REAL ESTATE EQUITIES  
Lyndale Ave Apartments  
955 Lyndale Ave  
Bloomington, MN

SITE PLAN APPLICATION  
12.09.2025

1 A001 - SUBLEVEL 1 PLAN - OVERALL  
A001.0 1/16" = 1'-0"

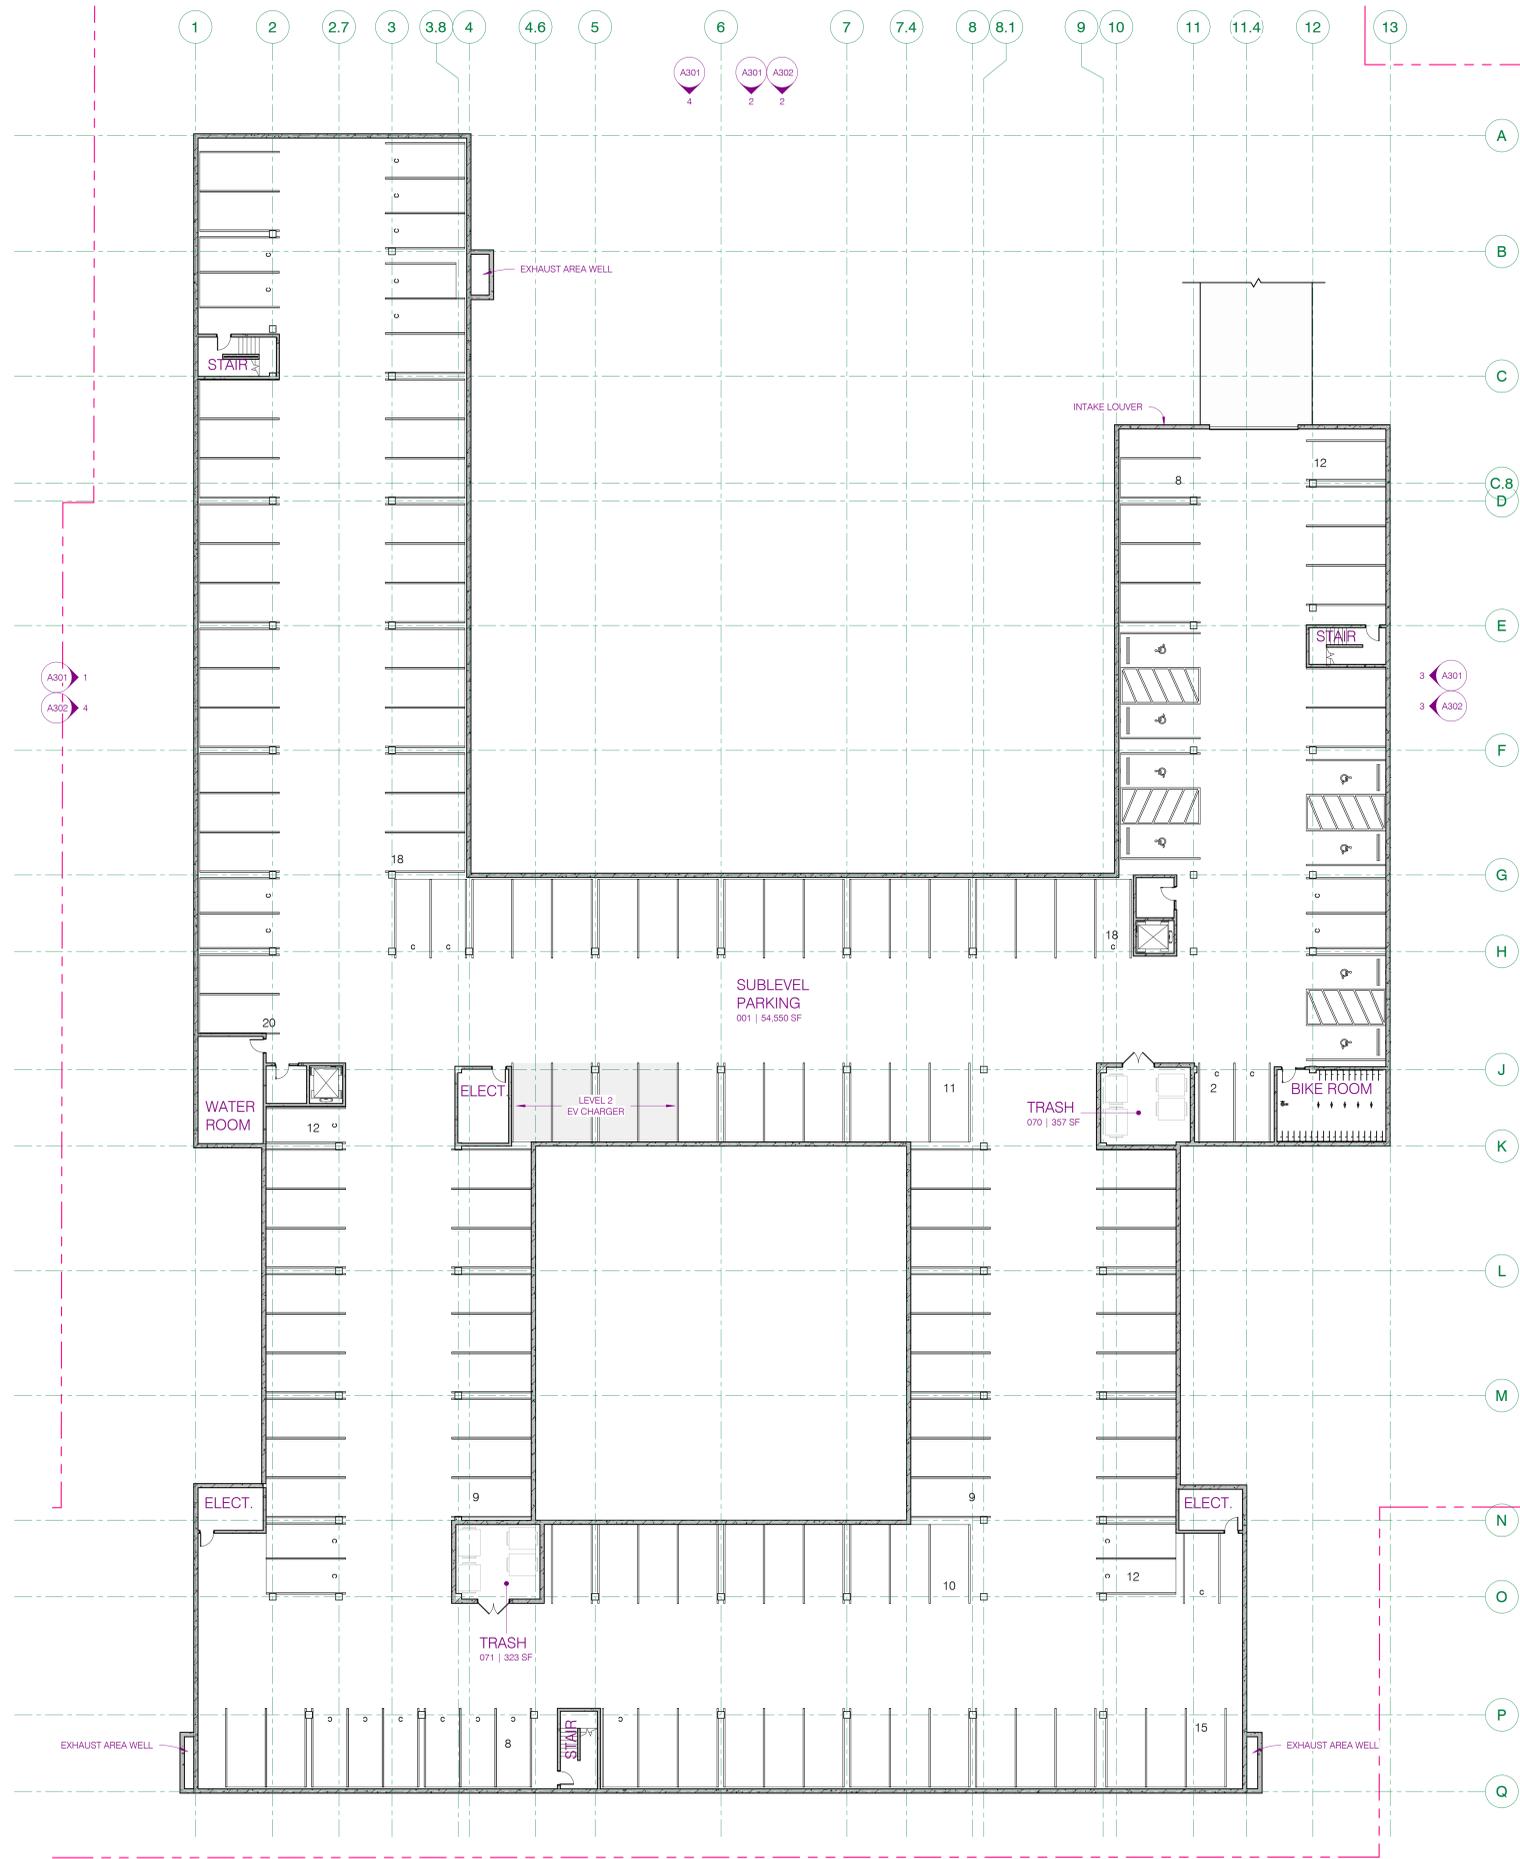
Must meet 2020 MN State Building Code

Must meet 2020 MN Accessibility Code.

Building plans must be signed by a MN licensed architect.

Provide a detailed code analysis with the plans.

When plans are 80% complete please contact Building & Inspections to set up a Building Code review.

SAC review by MET council will be required.  
On January 2nd, 2025, the City of Bloomington implemented a City SAC change. The cost will be \$1,026 per City SAC unit. The amount of SAC charged will mirror the MET Council Determination. This applies to any permits submitted on or after 01/02/25.

Must meet 2024 MN Energy Code and any testing/commissioning requirements.
